14 July 2023

PROPOSED CONSTRUCTION OF 5 DETACHED DWELLINGS WITH ASSOCIATED GARAGES, PARKING PROVISION, ACCESS AND LANDSCAPING – HINCKLEY AND BOSWORTH BOROUGH COUNCIL APPLICATION REFERENCE: 23/00311/FUL

LCC COMMENTS DATED 24 APRIL 2023

Client	Cartwright Homes	
Project	Residential Development Chapel Lane Witherley	
Drawing	Proposed Site Layout	
Scale	1:500	Sheet A3
Date	28.03.23	Author JET
Job No.	22-124	Drawing No. P02-D
Drawing Status	Planning Submission

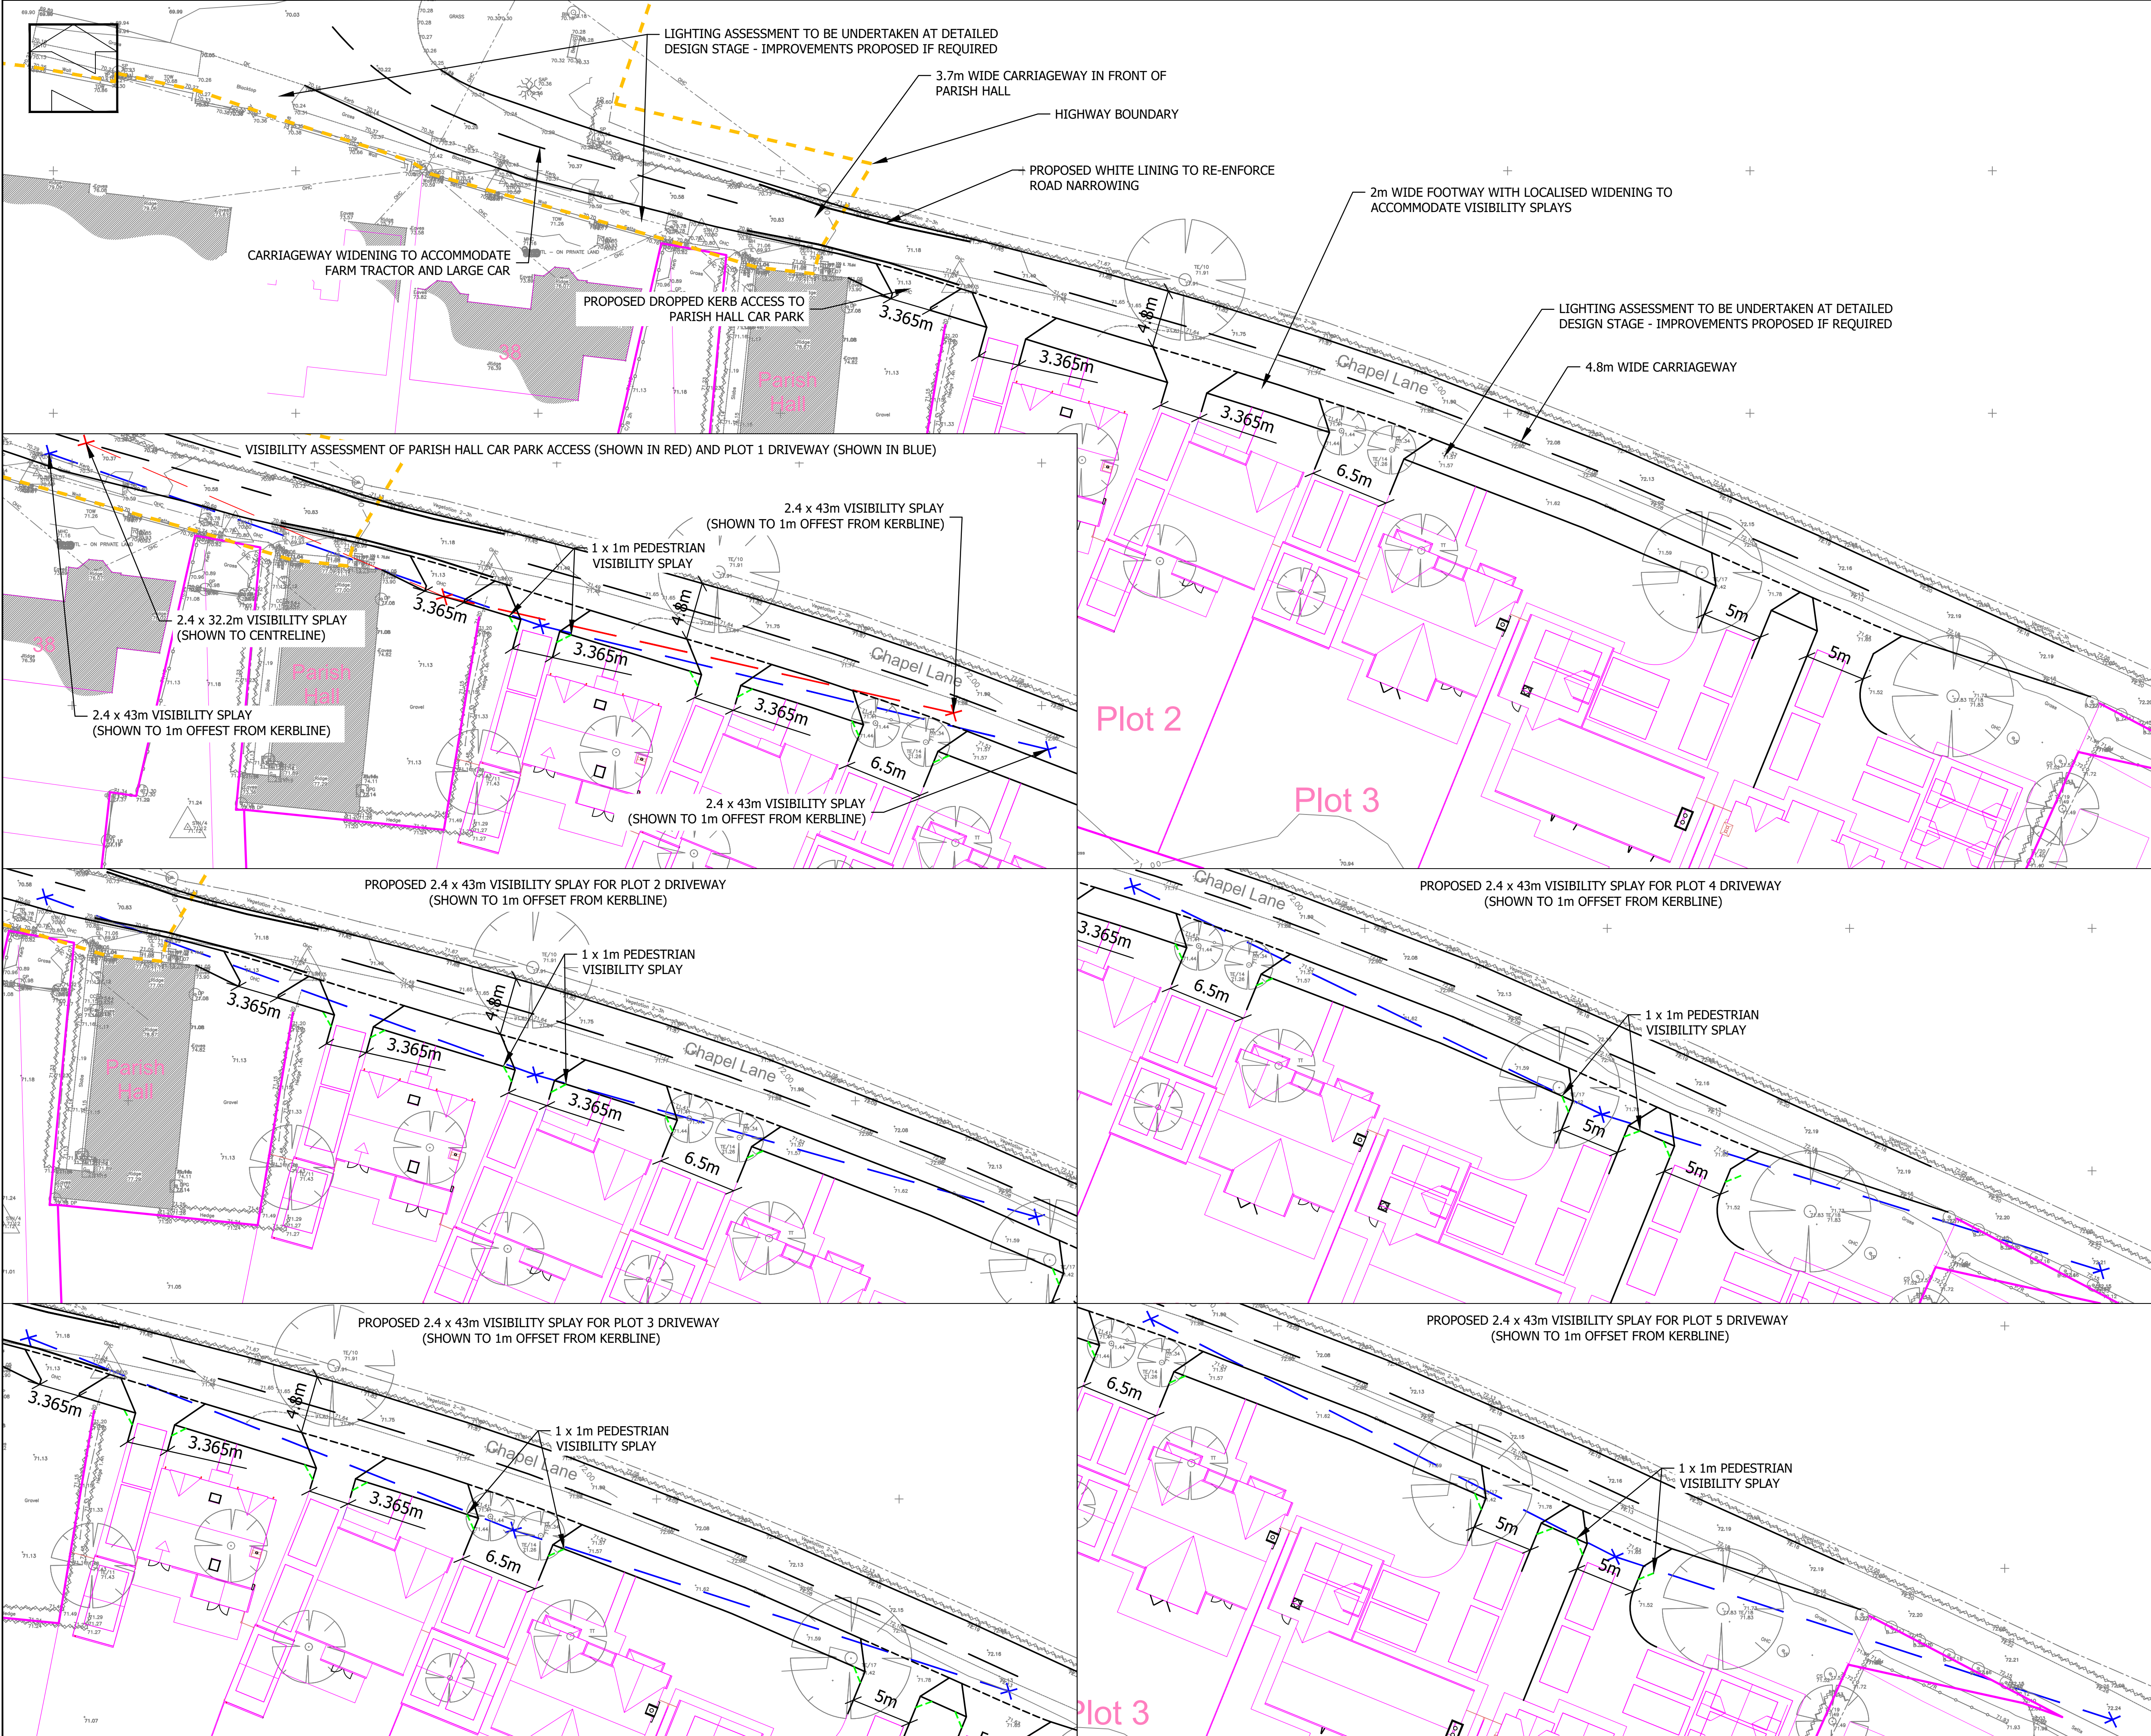
For example 'Proposed Site Layout', drawing number P02 and drawings/information as submitted within the 'Transport Statement do not correspond, these include but are not limited to; all plots layouts are different and there appears to be no 2m footway to the front of the proposed plots.

The LHA note that 'Proposed Site Layout', drawing number P02 demonstrates a proposed Parish Hall Car Park. However, the drawing does not demonstrate a redline to the highway in order to access either the private or the public highway. Whether to the east or west of the Parish Hall, the Applicant would be required to provide hardstanding for a minimum of 5m behind the boundary. Access via the west of the Parish Hall would also be complicated by the fact Public Right of Way T28 runs through the access. As such, the Applicant should provide access details to the proposed car park including a revised red line plan.

Details of the car park should also be provided. This should include some form of delineation within the site that clearly identifies parking spaces and turning within the car park. Spaces and turning should be provided in accordance with Paragraph 3.165 and Figure DG13 of Part 3 of the Leicestershire Highway Design Guide (LHDG).

The additional area allocated to the Parish Hall as shown on the updated Proposed Site Layout plan would be an extension of the existing informal parking area, which is currently a grassed area. The

allocated area has been provided for the Parish Hall to decide how they want to use it. Therefore, it is not necessary to mark out parking spaces.

Rev A: Footpath added in response to Highway comment - JET - 12.05.23
Rev B: Splays amended in response to Highway engineer - JET - 21.06.23
Rev C: Footpath & Splays added in response to Highway engineer Xref- JET - 10.07.23
Rev D: Splays amended in response to Highway engineer Xref- JET - 10.07.23
